Board of Adjustment
Variance
Staff Report & Findings

TO: Town of Woodfin Planning Board of Adjustment **DATE:** June 4, 2024

SITE INFO: Street Address: 66 Lake Town Lane
Tax Description (PIN): 9730-99-4827-00000
Zoning: R-7 Residential District (R-7)
Property Owner: Lake Town Lane Revocable Trust

SITE INFO: Street Address: 15 Elk Mountain Road
Tax Description (PIN): 9730-73-2519-00000
Zoning: Community Shopping (CS)
Property Owner: WAGB, LLC

L-1.2

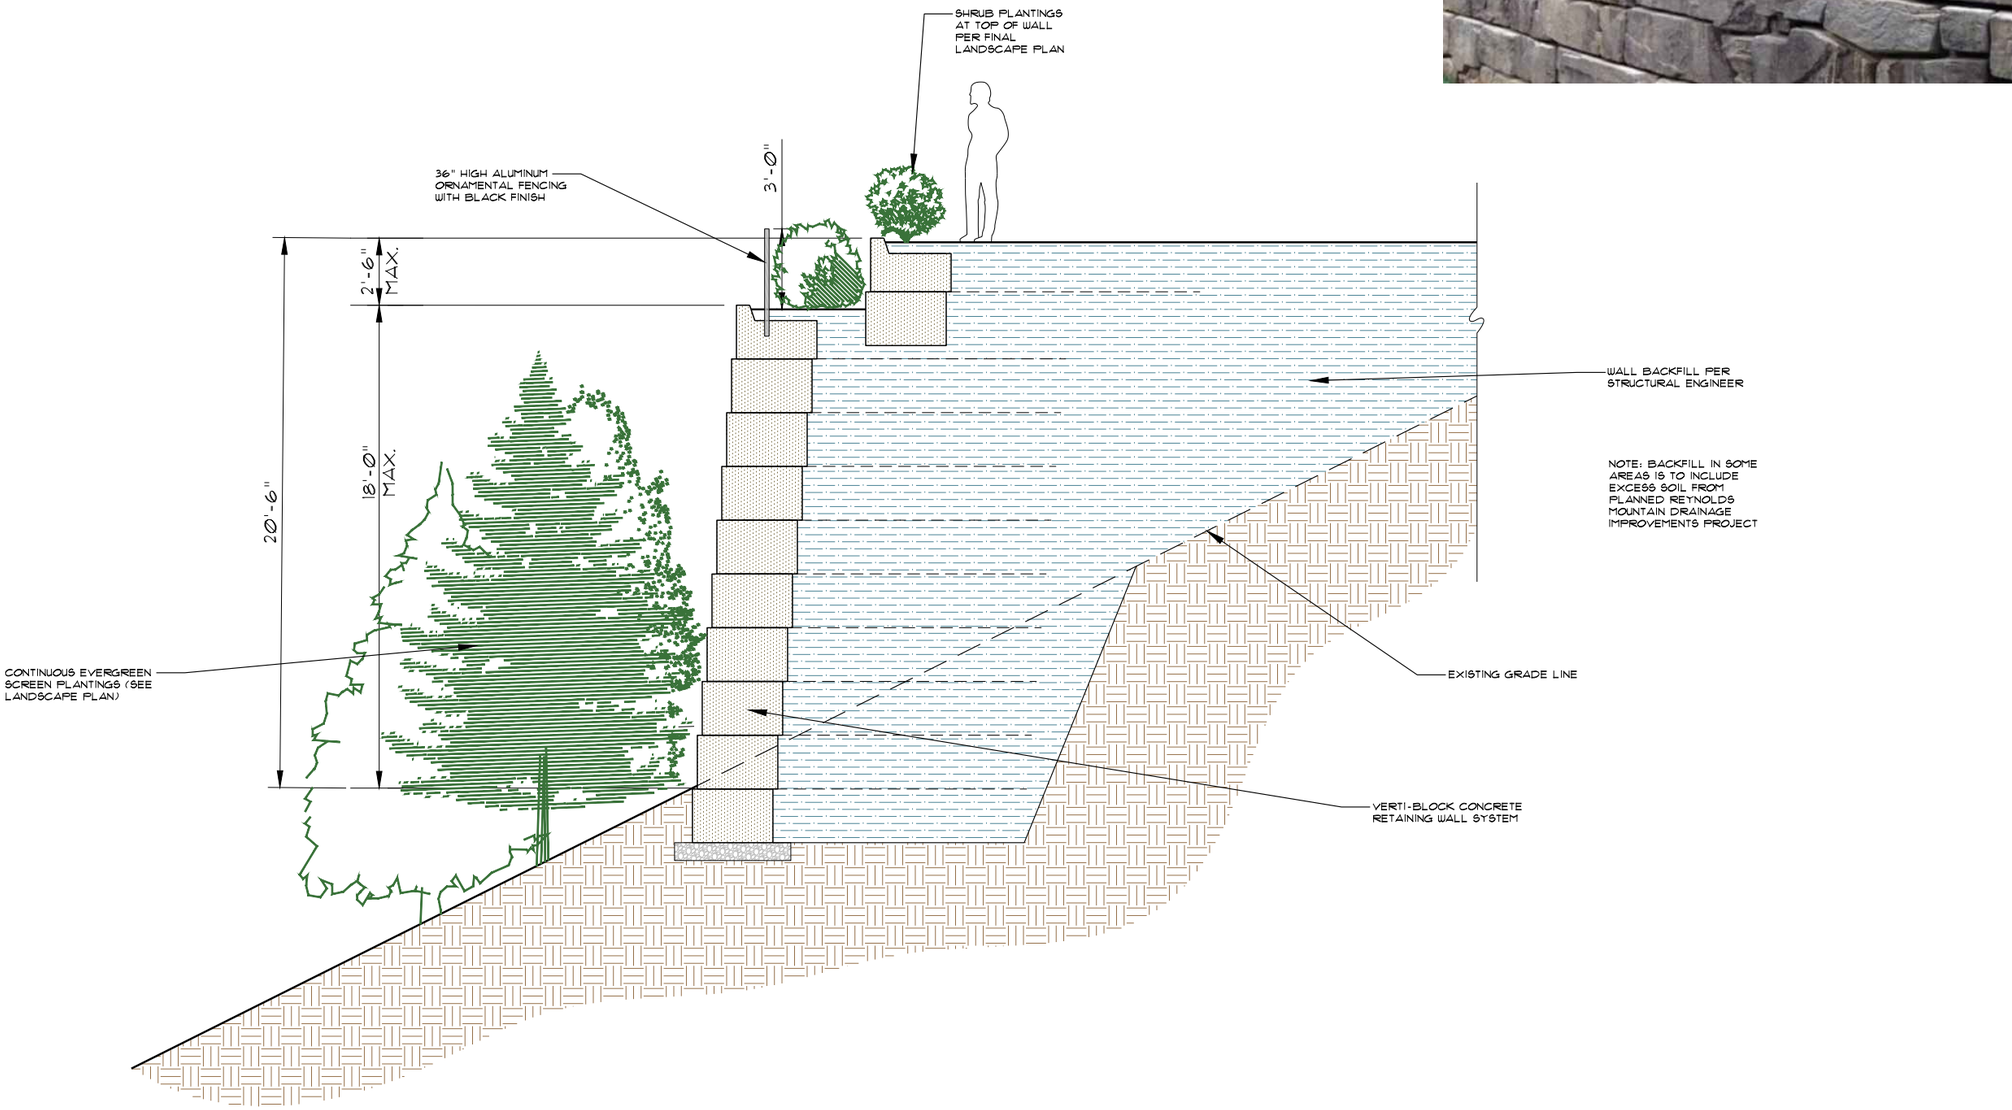
Retaining walls are defined and permitted as accessory structures under the Town's zoning ordinance. The Steep Slope section limits the maximum height of retaining walls to 12 feet and includes the use of stacked or tiered walls. Staff interprets a wall to be stacked or tiered when the horizonal distance between walls is less than the vertical height of the tallest wall. For this reason, the total wall height is determined to be 20 feet, 6 inches rather than the 18 feet height of the single tallest wall reflected on the plan.

Should the board wish to grant the variance, staff recommend three conditions: 1) that any home constructed be limited to one-story and 24 feet in height when constructed above the wall, 2) that the overall size of the home be limited to 3000 square feet, and 3) the wall be made of, or resemble natural stone that will be camouflaged against the native vegetation. Failure to place additional limits on the height of any dwelling has the potential to allow up to a 35-foot-tall house above the elevated construction site, resulting in greater visibility downslope and from other vantage points.

1 SITE PLAN

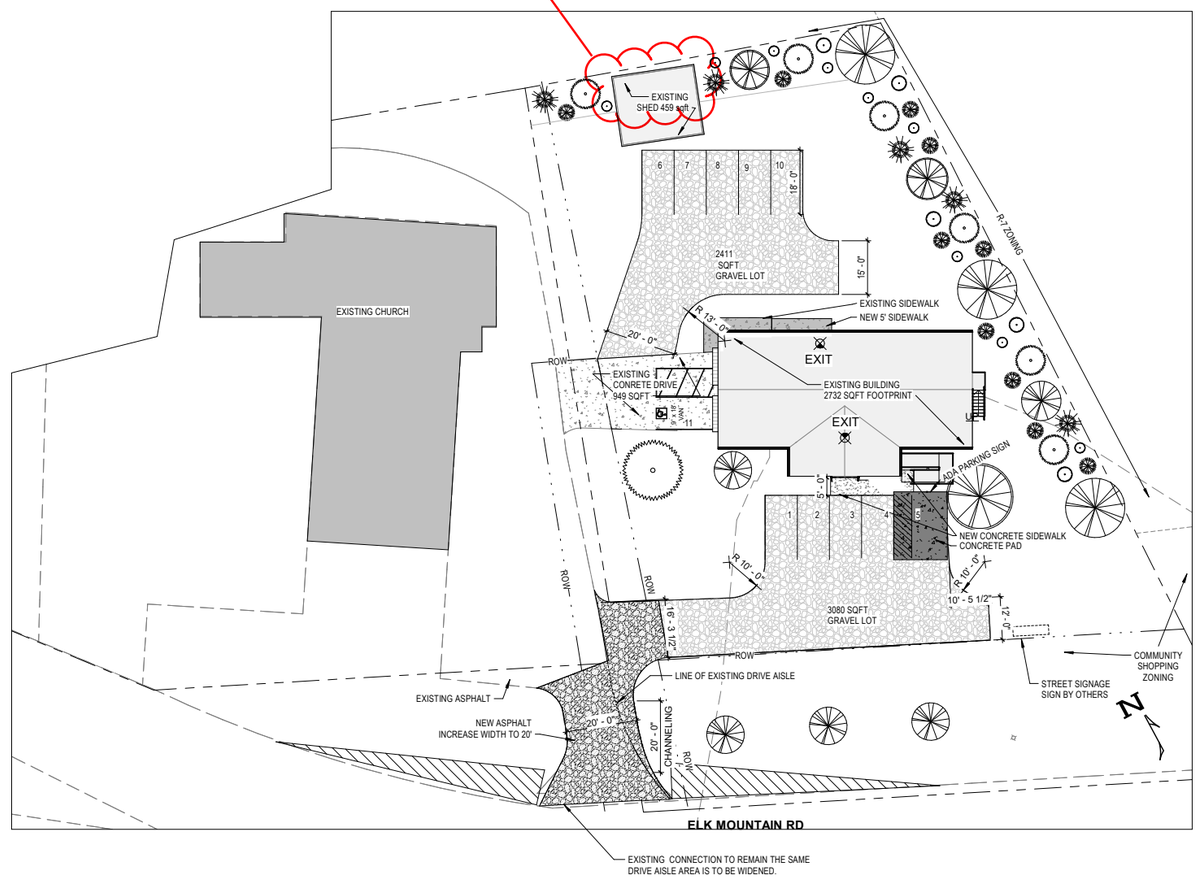
In reviewing the site plan, staff noted the existing shed located at the rear of the property creates two nonconforming situations: 1) the building encroaches into the required 15-foot setback; and 2) the building encroaches into the required 10-foot buffer strip. The setback encroachment does not need any variance or modification from the zoning ordinance when evaluated against **Article XII. –**

However, the existing shed is located within a portion of the required 10-foot buffer strip and prevents compliance with the required screening. The structure's approximate encroachment of 23 feet width and 9 feet depth into the required buffer strip prevents installation of the prescribed plant material. The remaining 1–2-foot depth appears insufficient to accommodate any type of vegetation required for screening and buffering of incompatible zoning districts. Town staff would recommend that if the variance were granted, that the following conditions be added: 1) That if the building is demolished or relocated that the full buffer strip will be installed as required by ordinance; and 2) no additions shall be allowed that increase the degree of nonconformity.
